Design Review Subcommittee (DRSC)

Meeting Date: July 27, 2015

SUBJECT: **Architectural Permit 14-389/Variance 14-474/Conditional Use Permit 14-475 – Capistrano Shores Wall and Landscaping**, a request to consider a variance for a decorative block wall with accent columns in excess of six feet in height between the railroad tracks and the Capistrano Shores Mobile Homes Park, along with a Conditional Use Permit to allow the accessory structures, landscaping, and utility improvements in an open space zone at 1880 N. El Camino Real within the Open Space zoning district and Coastal Zone Overlay (OS2-S2-CZ).

Exhibit 1 - Previous and Proposed Details

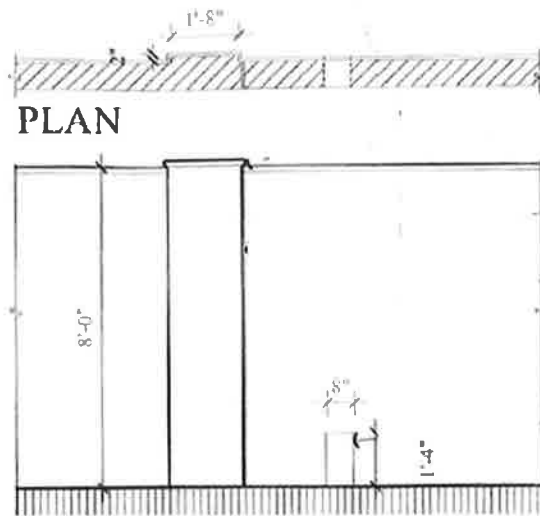
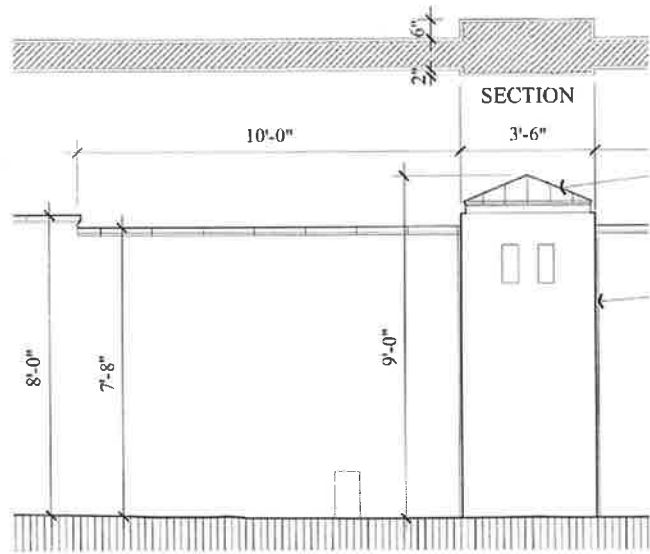
<p>Ensure that in all respects the wall is in proportion and to scale with proposed heights and massing. Also asked applicant to review wall cap width and suggesting increasing it to be in scale with eight-foot wall.</p>	<p><i>Portions Modified.</i> The proposed width of the columns have been increased from 1’-8” to 3’-6”, but have been raised to nine feet in height. The applicant discussed increasing the wall cap from 2” to 3.5” and their architect believed that the 2” cap is a preferred aesthetic choice.</p>
<p>Please provide a full elevation of the wall.</p>	<p><i>Provided.</i> See architectural plans.</p>
<p>Modify entry columns so they are incorporated with the wall.</p>	<p><i>Modified as requested.</i> The columns are now incorporated and a pedestrian entrance is provided via an archway.</p>

Staff is also concerned with the flat tiles proposed for the columns of the wall, and would want to see a detail of the proposed application. Staff recommends a traditional single barrel roof tile with mortar packing cap to match the entry columns, or a flat column cap to help reduce the height of the detail. Staff seeks DRSC's comments on the modifications and welcomes any feedback.

Exhibit 2: Columns and Trellis

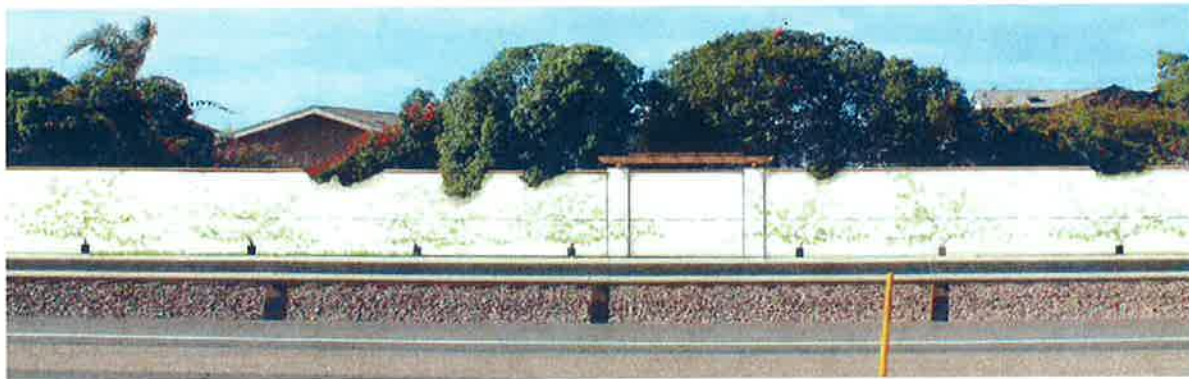
**The columns are shown in the renderings but need to be added to the plans prior to Planning Commission.*
